RELOCATION OF GATES 10 & 11

**PROJECT NO. 54 1019 1765
CONTRACT NO. 54-2-20-2111**

ADDENDUM NO. 1

March 27, 2020

BID DOCUMENTS
DRAWING: AE201
PROJECT: 54 1019 1765
SHEET: 91 OF 127

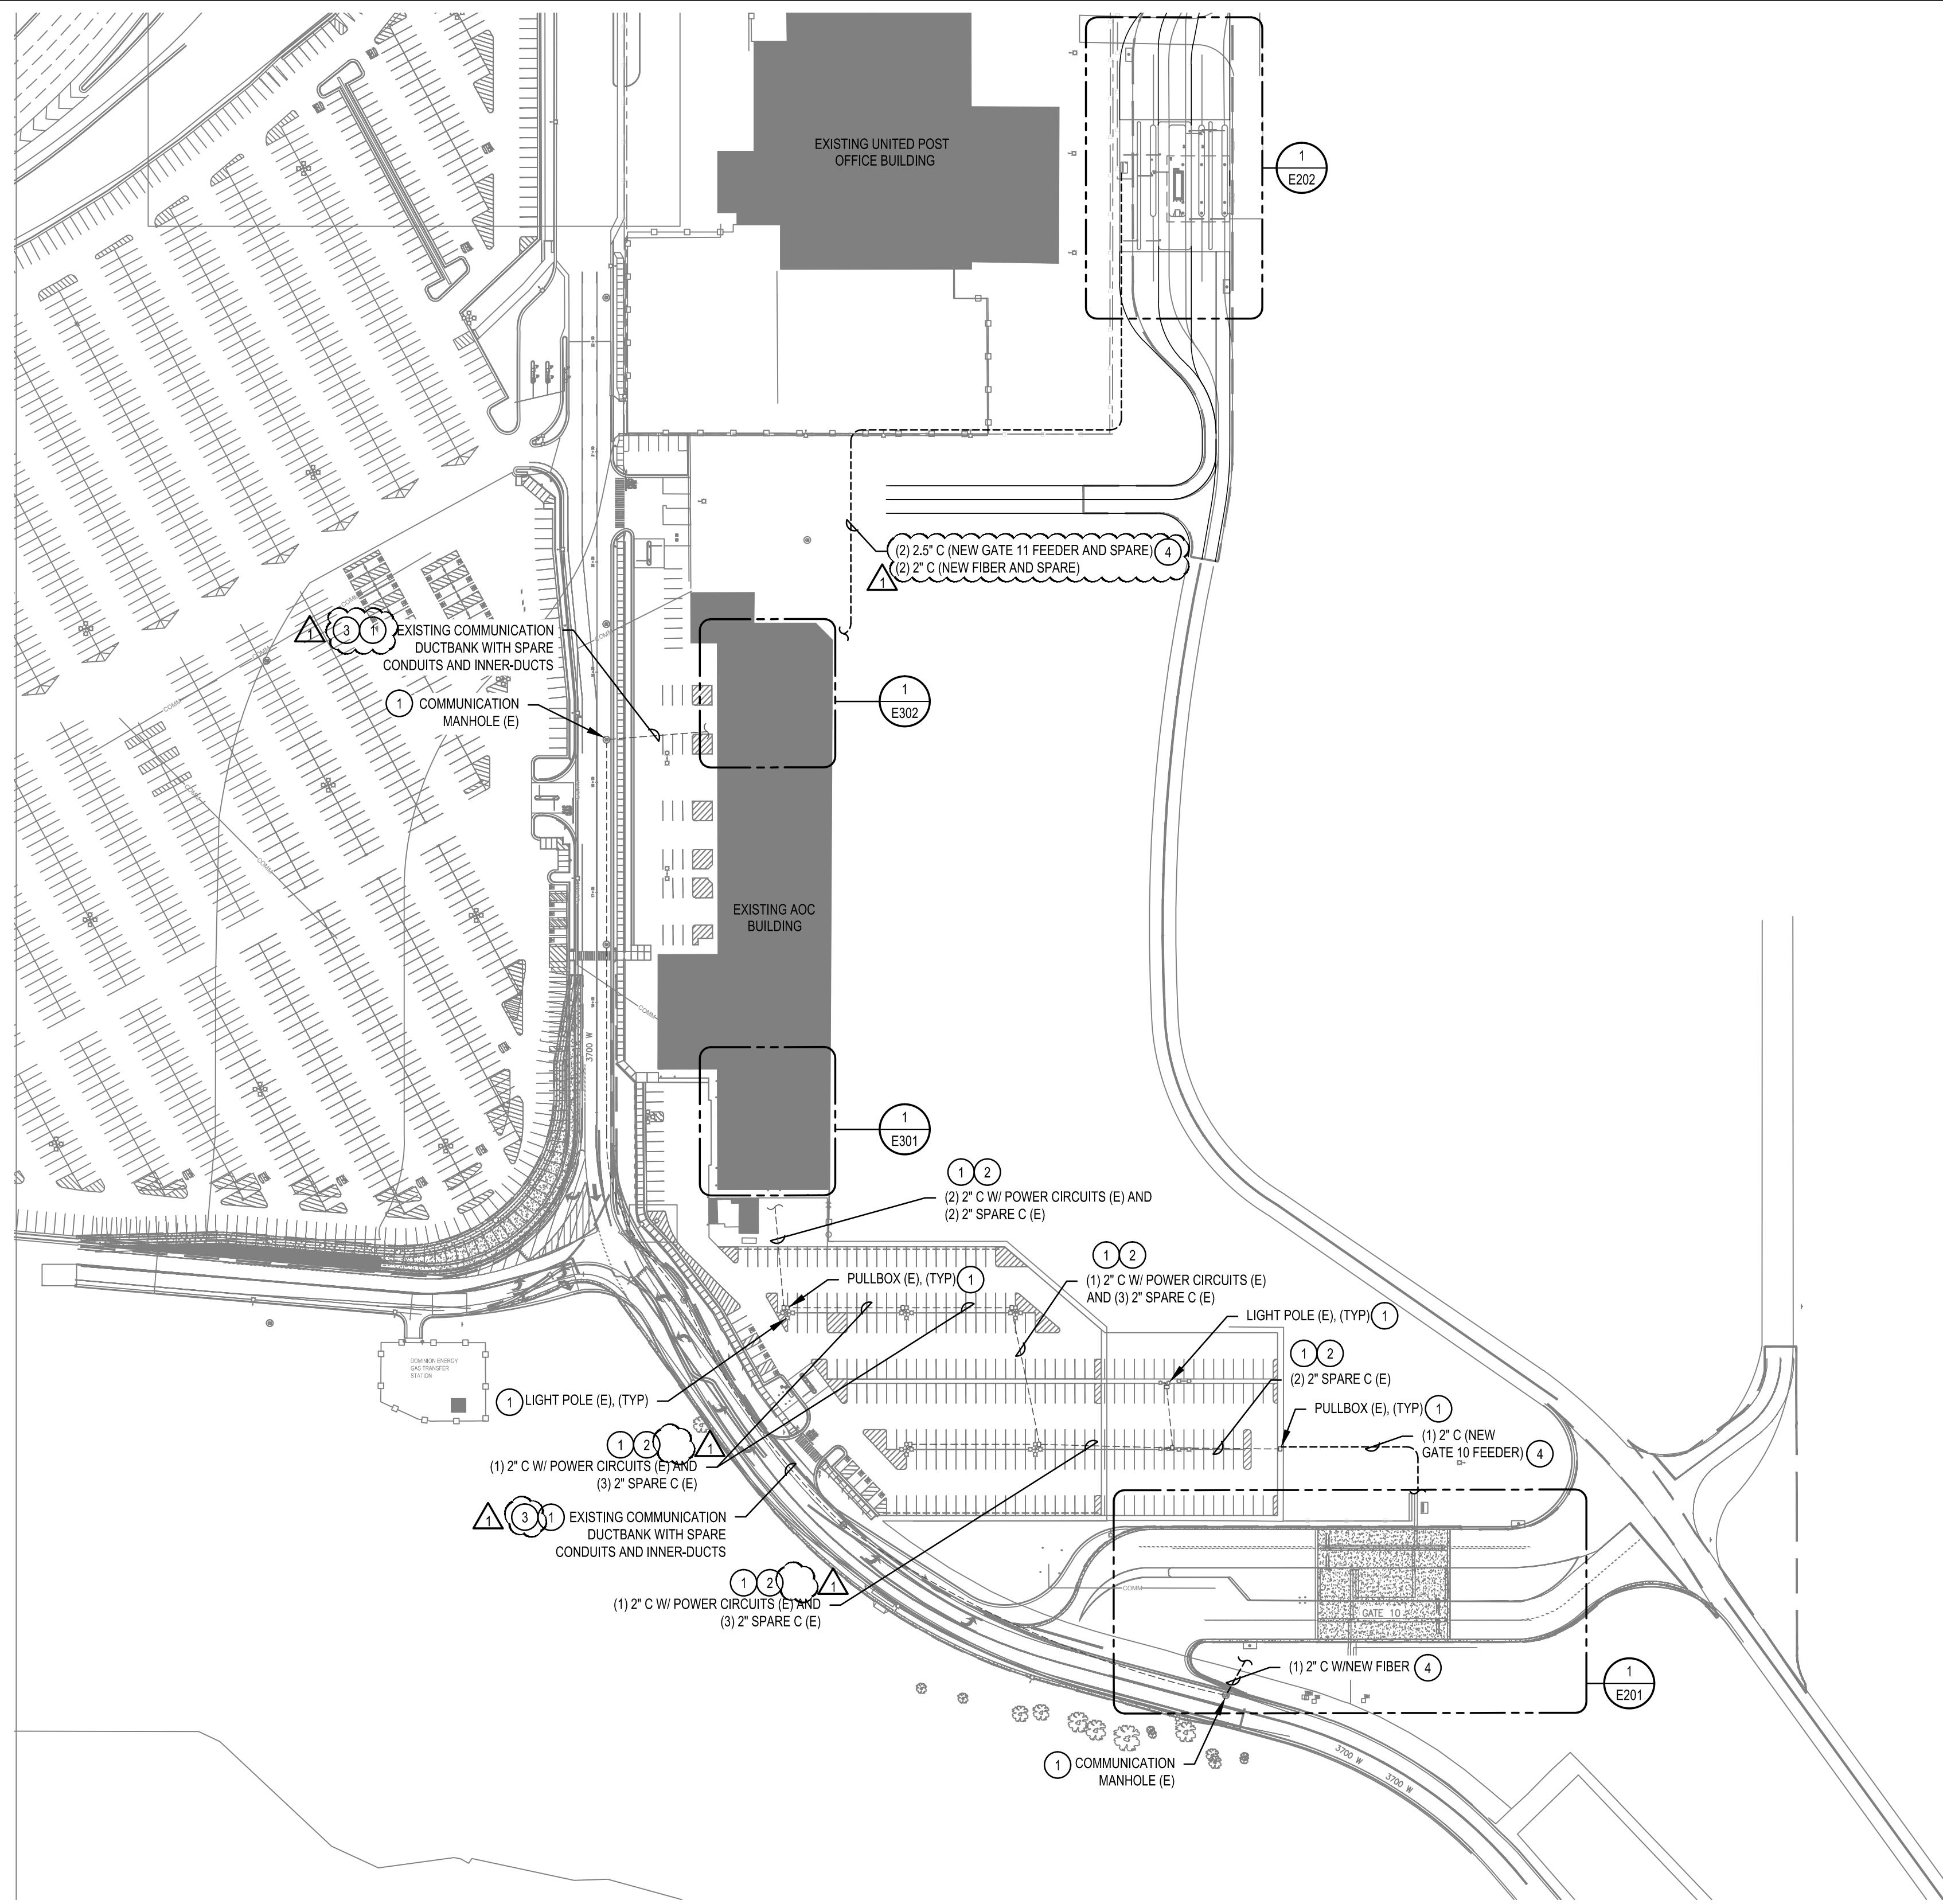
AE201 Addendum No. 1 - Updated east elevation to show exhaust fan grille.

BID DOCUMENTS
DRAWING E100
PROJECT 54 1019 1765
SHEET 117 OF 127

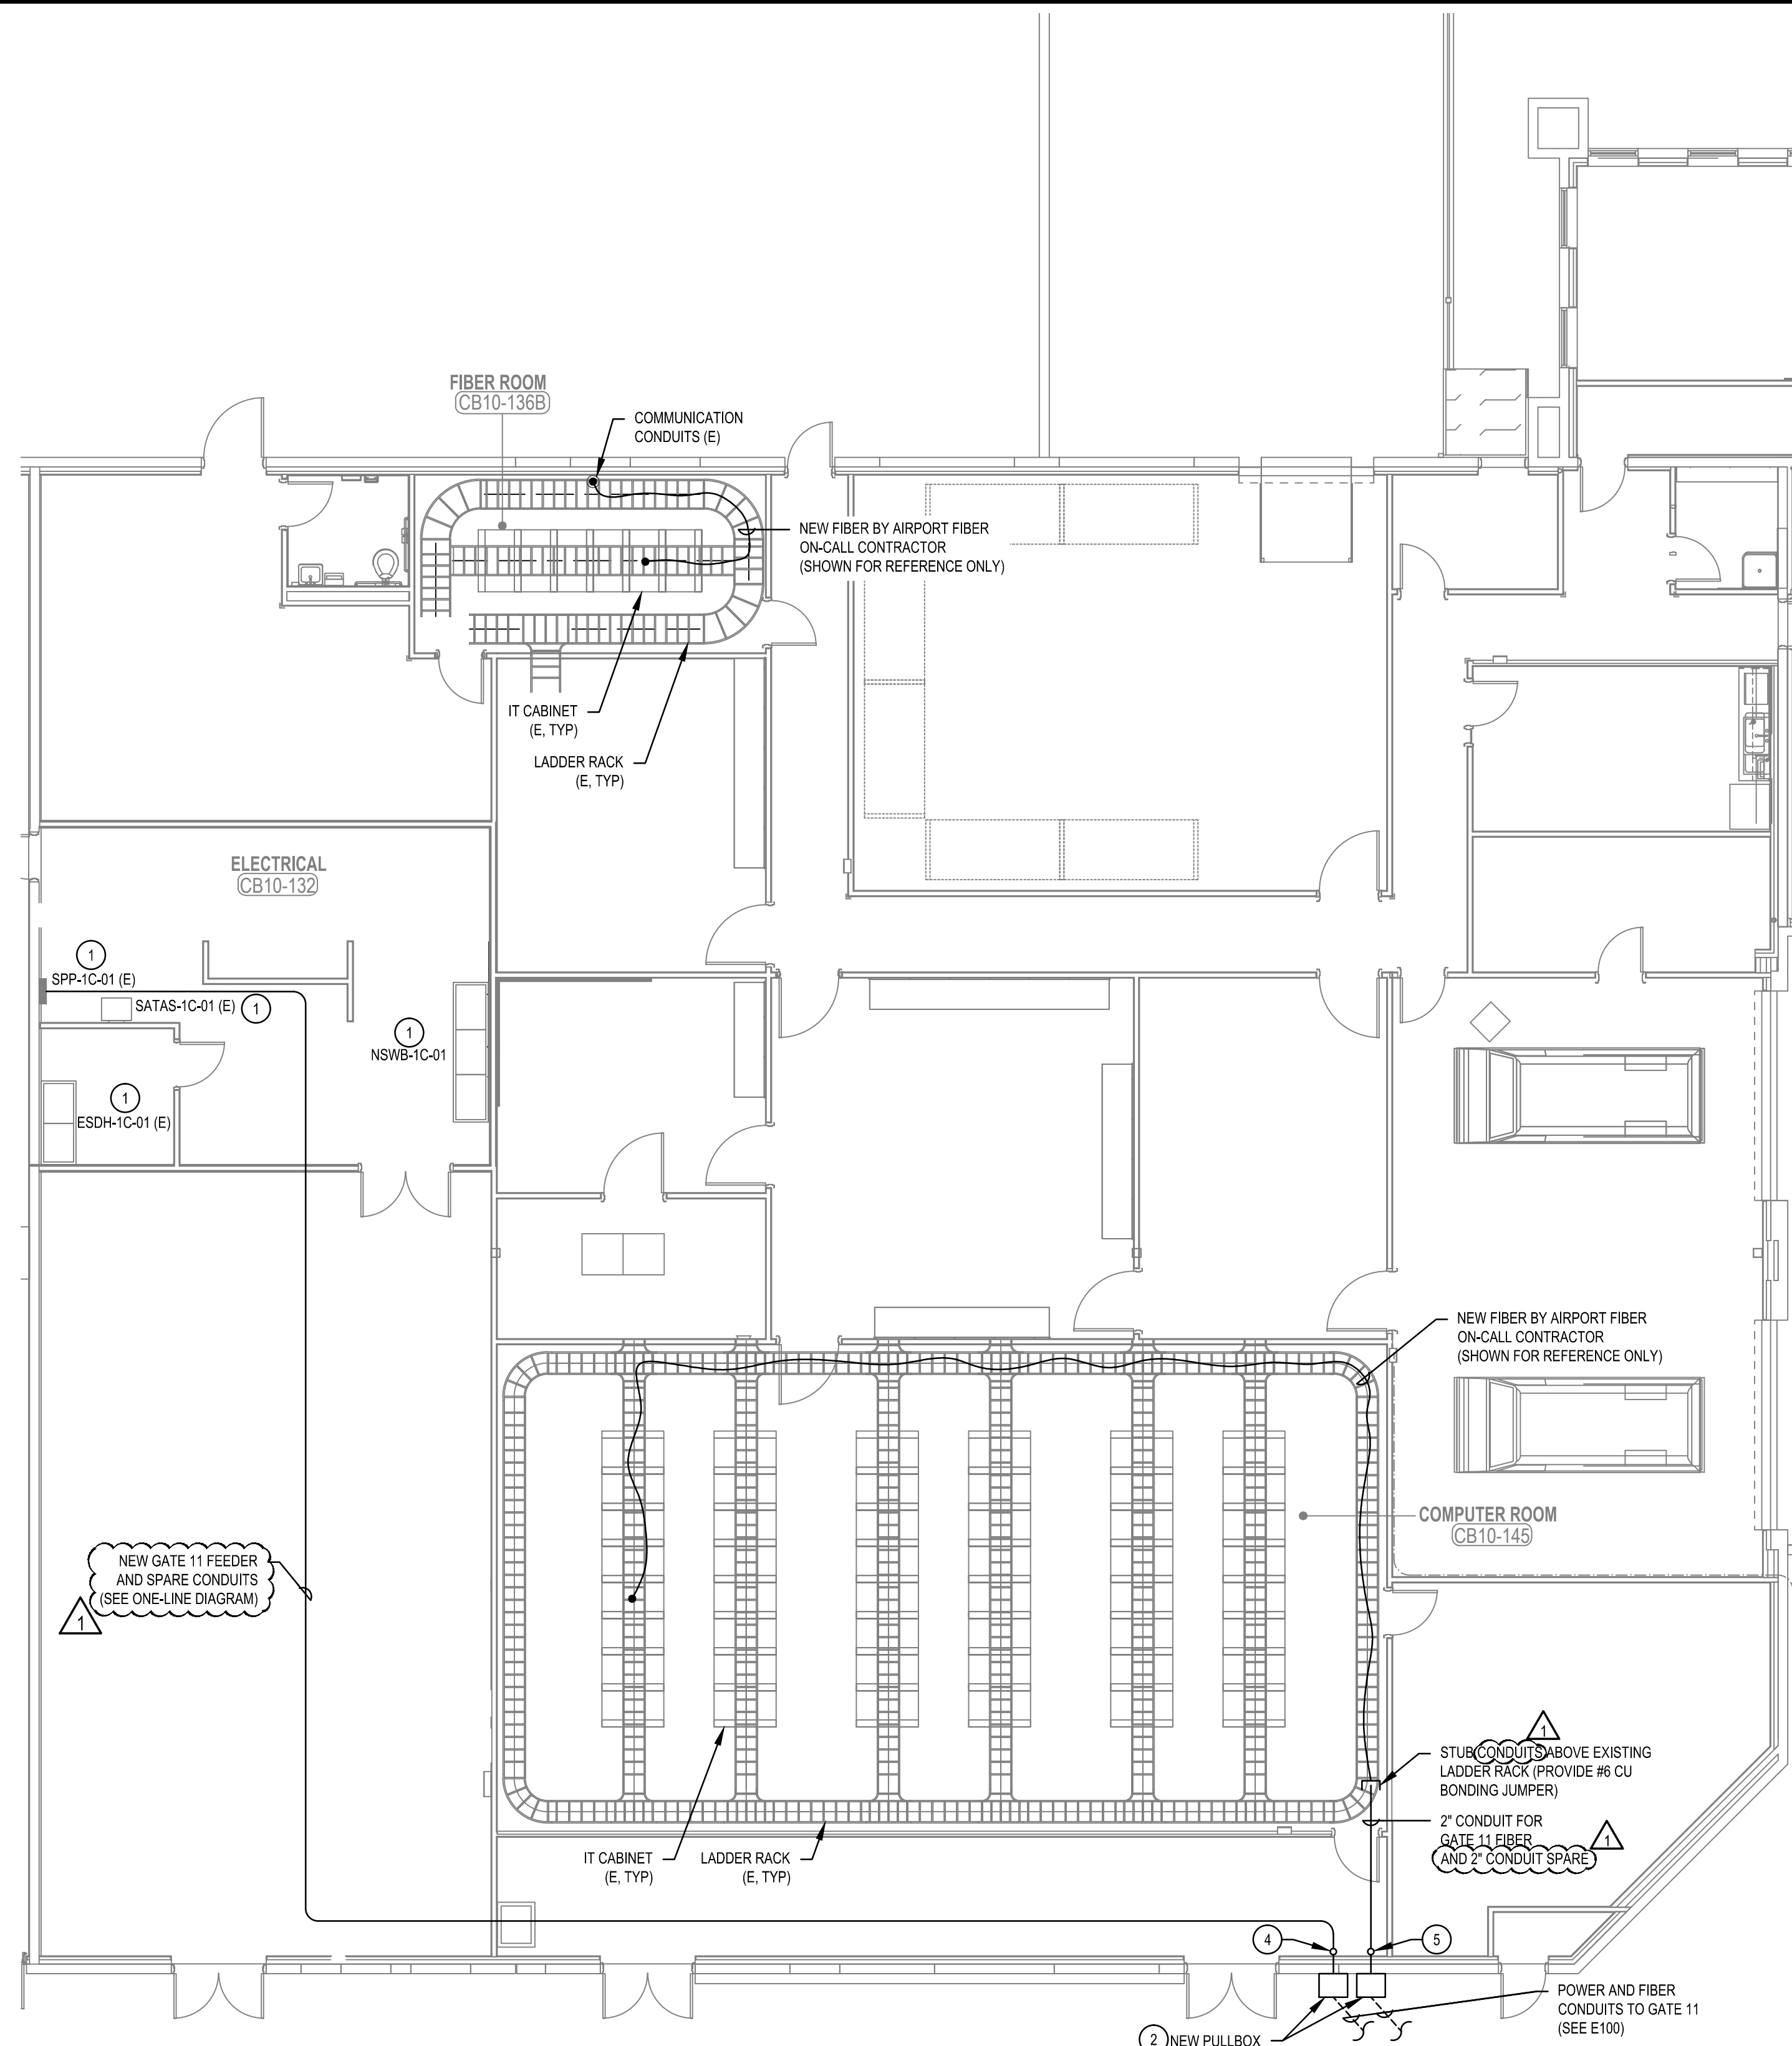
E100 Addendum No. 1 - Revised keyed note 3, Added and removed keyed notes from the site plan. Added spare conduits to Gate 11 and revised power conduit size.
